ECN No: ECN202412110001

Subject of change: Notice on Housing Material Change of HFD4 THT Types

PN: HFD4 THT types

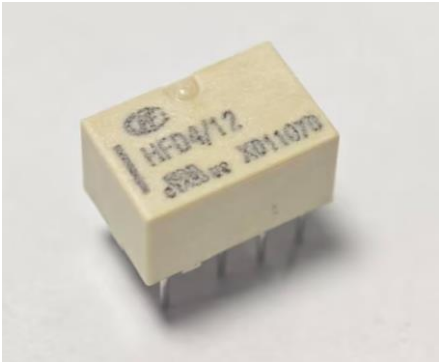
Reason for change: In order to reduce the supply chain risk of raw material and provide better L/T as well as service to customers, we decide to change the housing material from PBT to LCP which is in bulk purchase in Hongfa group.

Part	Before	After
HFD4	1、Housing material: PBT 2、Outlook: ① White ② See photo below 	1、Housing material: LCP 2、Outlook: ① Beige ② See photo below

We assume that the relay PN, performance, certificates and delivery will remain the same after change. The only slight difference is the color as shown above. The cost increased in this change will be absorbed by Hongfa.
